RE: St. Lucie Unit 1
Docket No. 50-335
Proposed License Amendment
Main Steam Line Break Crediting Non-Safety
Main Feedwater and Condensate Pump Trips

EVALUATION OF PROPOSED CHANGE
TO THE ST. LUCIE UNIT 1 MSLB ANALYSIS

ST. LUCIE UNIT 1 MARKED UP UFSAR PAGES

Figure 6.2-12

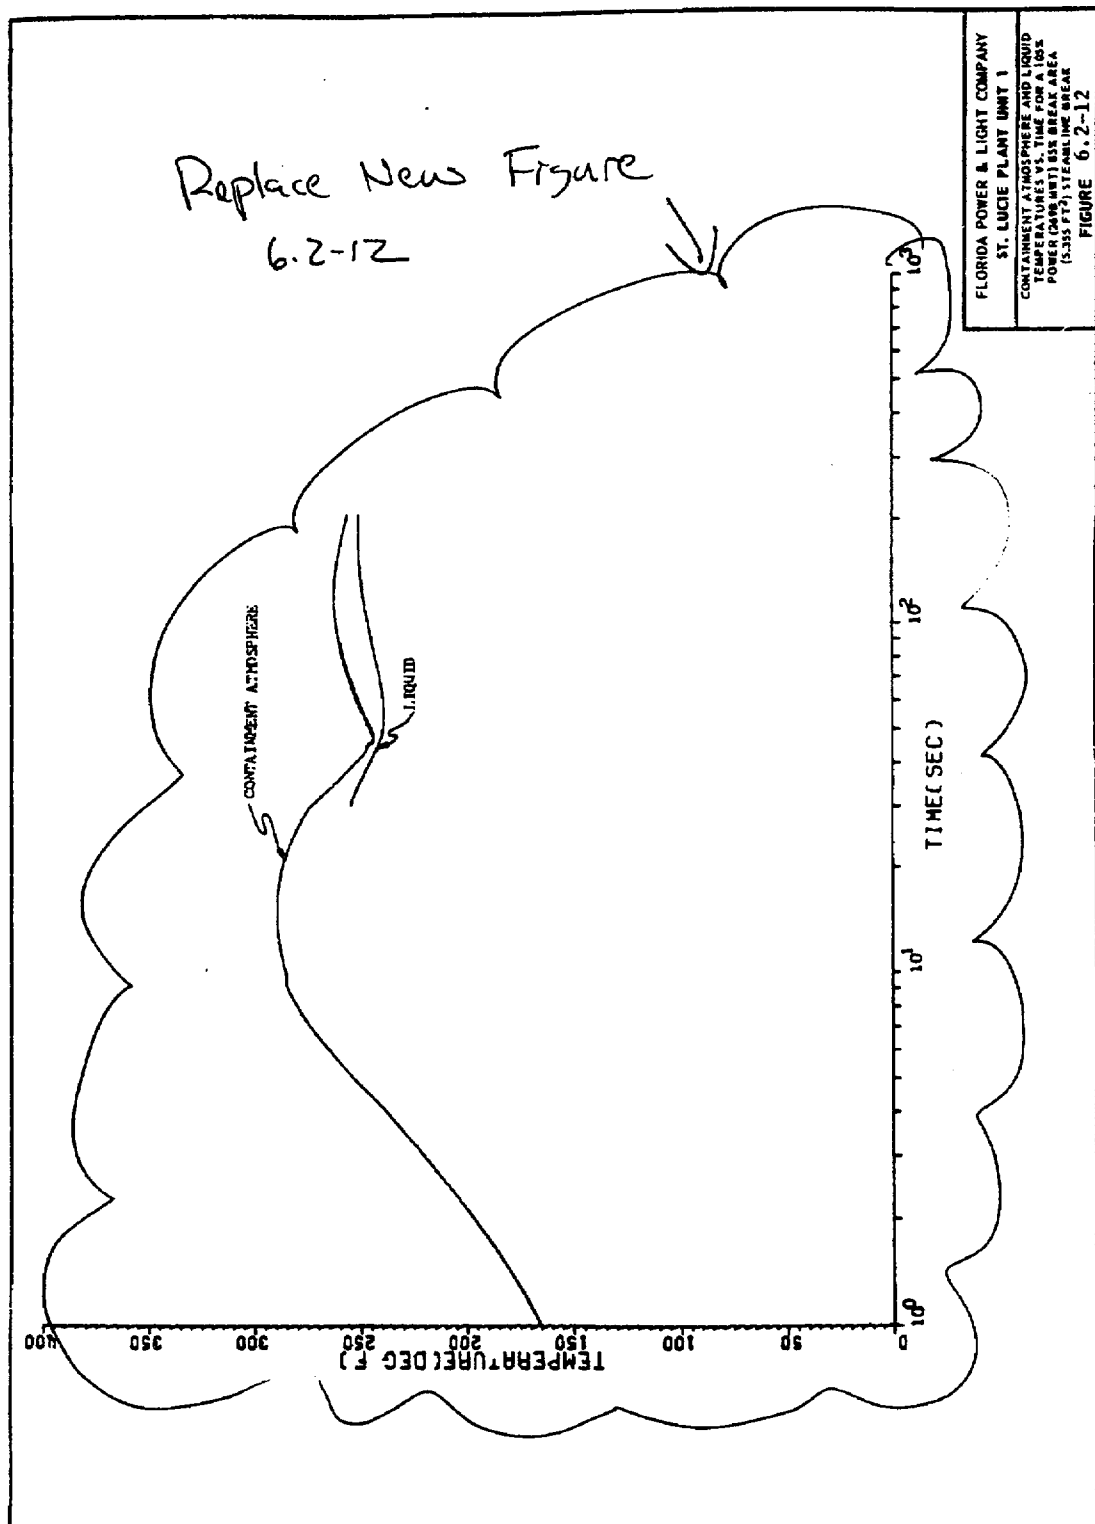
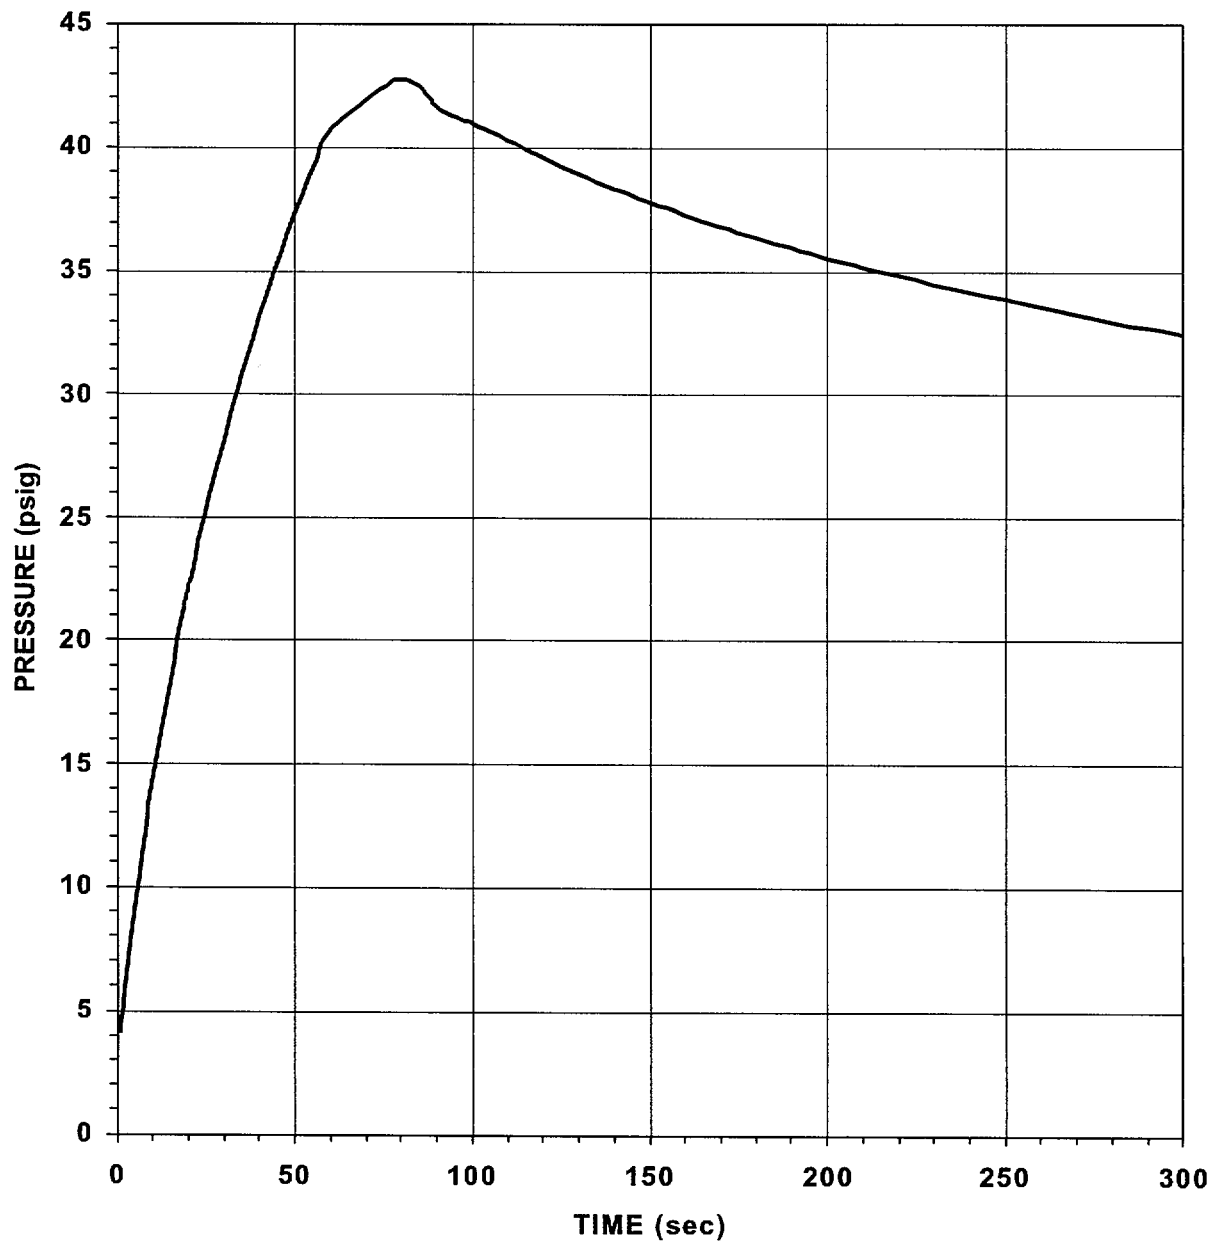
The pressure and temperature profiles for the containment response to the limiting MSLB are provided in Figures 6.2-12 and 6.2-13, respectively.

Figure 6.2-14

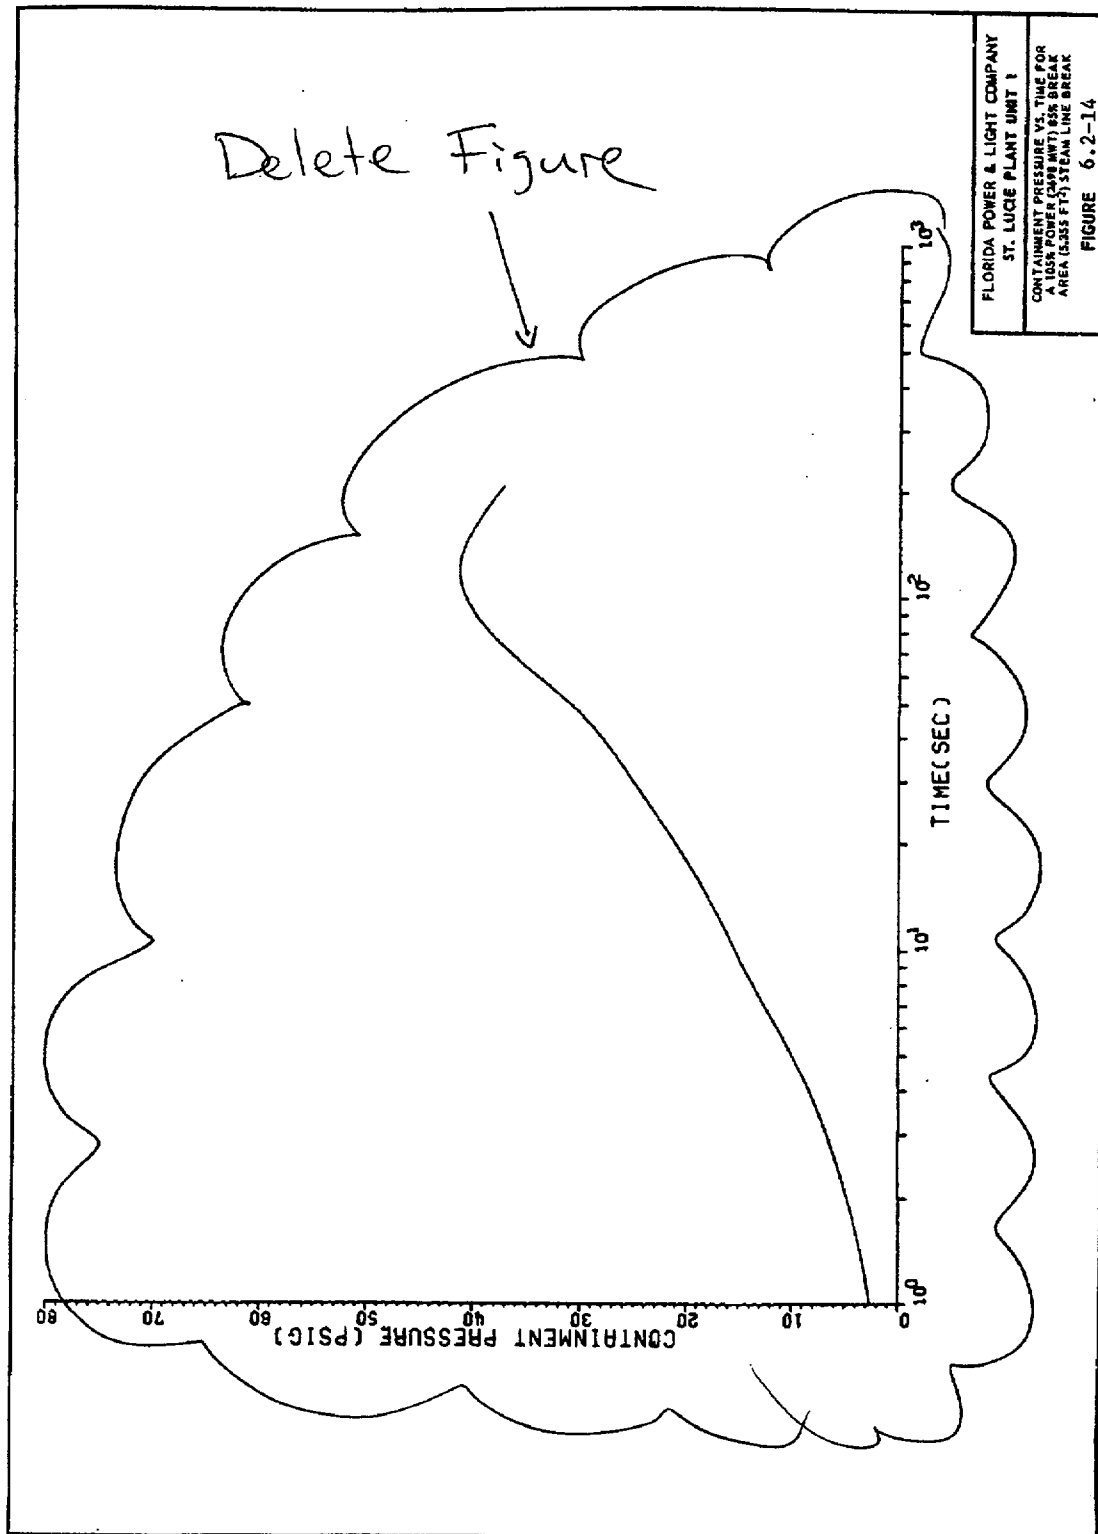
DELETED
